This page lists the known errors on the gm5x5x5 PCBs. There are no known issues with the bulk order run (white pcbs), the following information is valid **only** for the prototype run (green pcbs).

Bulk Order #1 (white pcb, rev 1.0)

Prototype Run (green PCBs)

#1 MIDI IO pins

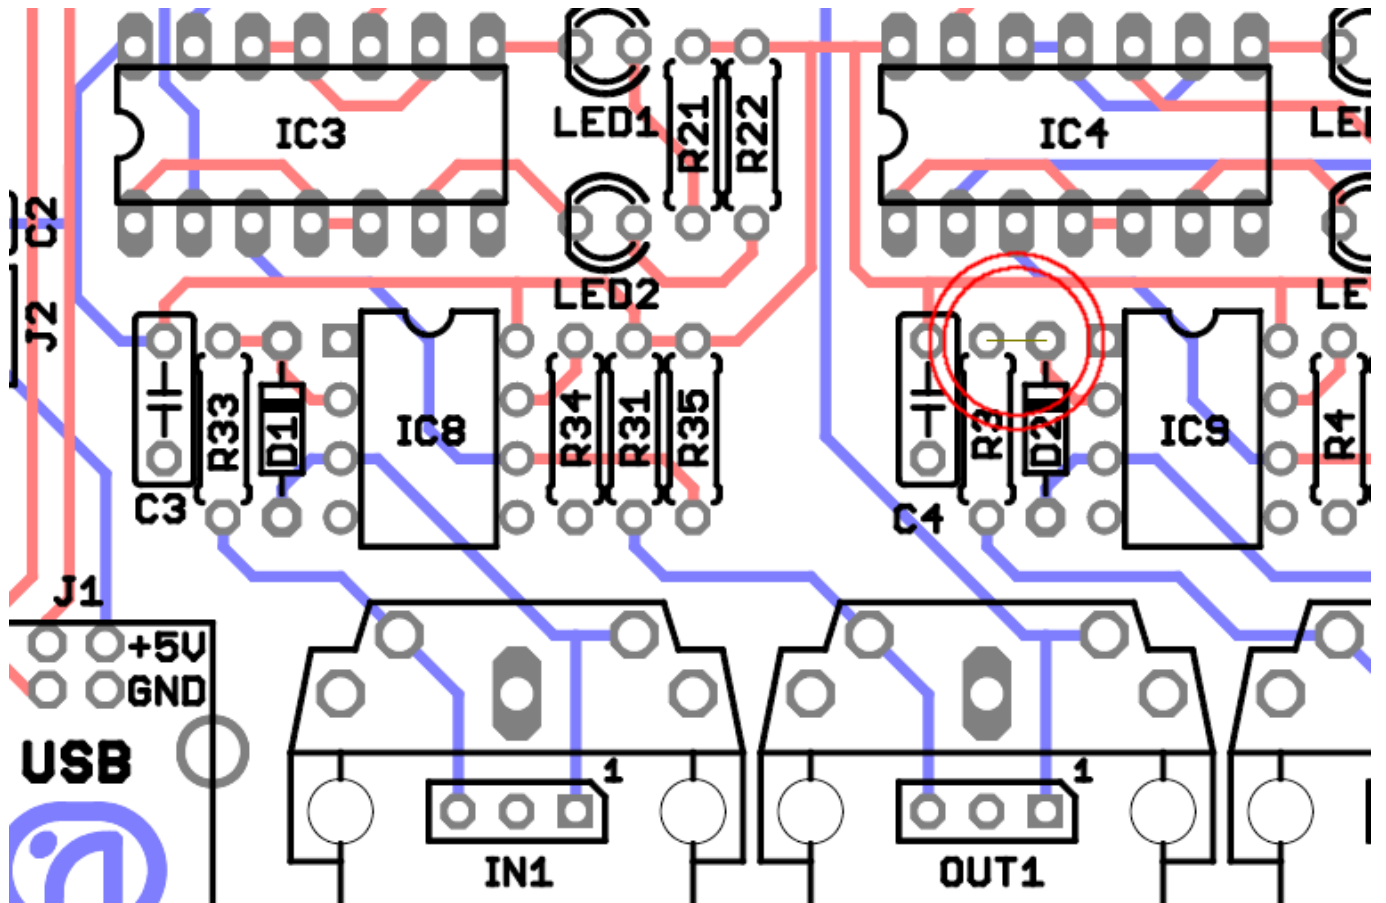
Problem: The MIDI IO pins of the midi sockets (Pin 4 + 5) are switched.

Solution: Either (1) use the pin-headers if you use sockets that are not mounted on the pcb or (2) break the traces to pins 4 + 5 of the sockets and solder wires to them or (3) solder the midi sockets on the other side of the pcb.
